RE: City of Taunton, MA
WWTF Phase 1 Improvements
Contract S-2021-1

Shop Drawing No. 03200-04 Rev1 Chlorine Contact Tank Rebar

Project: WWTf TAUNTON EAST & WEST EXTENSIONS
 Drawing: CHLORINE CONTACT TANK
 Customer: HART ENGINEERING
 Engineer: BETA INC.
 Refer to Release:
 Date Drawn Chkd. JOB No. Dwg. No.
 10/13/21 KML 34015329 CCT-01

CHLORINE CONTACT TANK - REINFORCEMENT PLAN
SECTIONS TAKEN AT WEST TANK EXTENSION - EAST TANK EXTENSION MIRRORRED

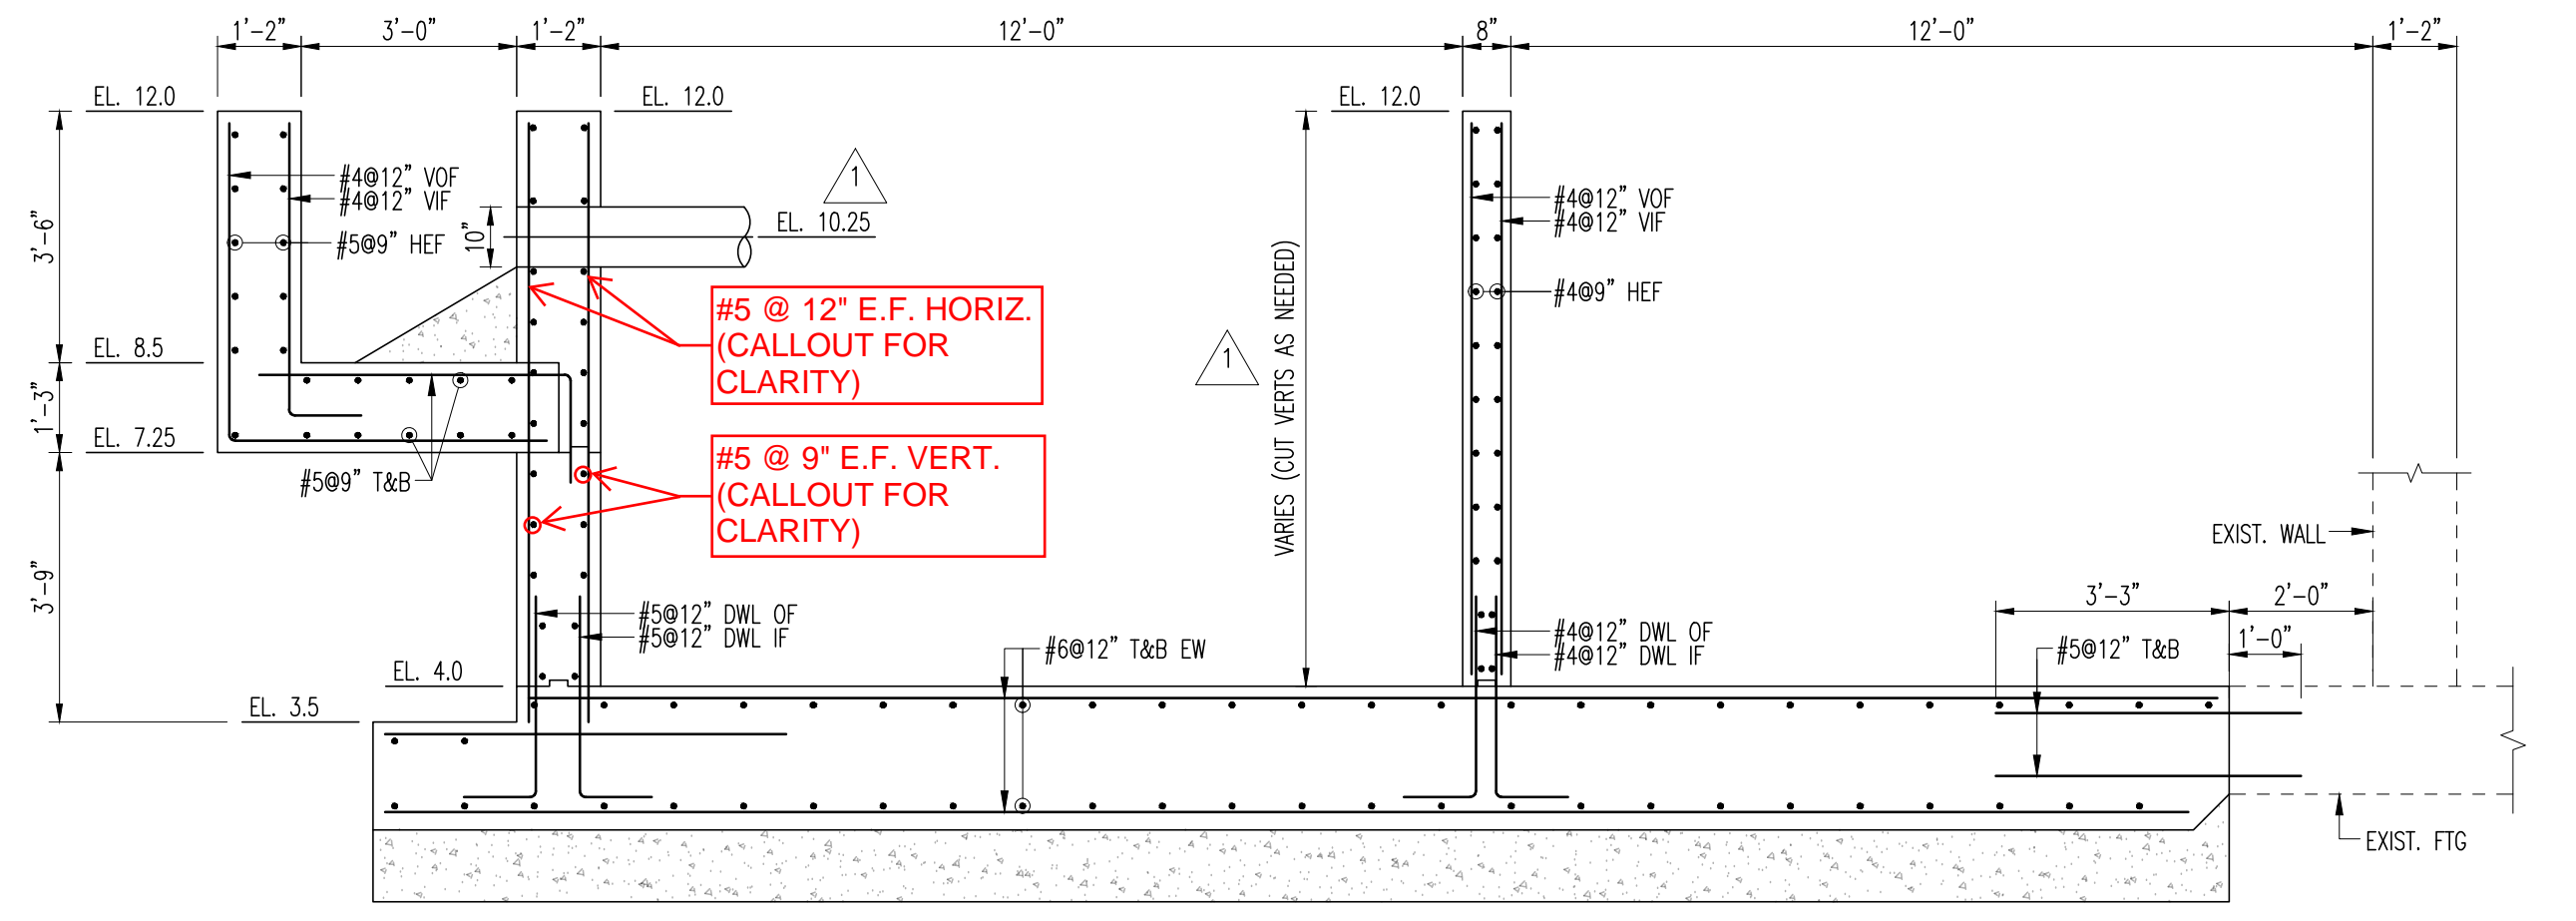
Please provide AIS (American Iron and Steel) Certificate.
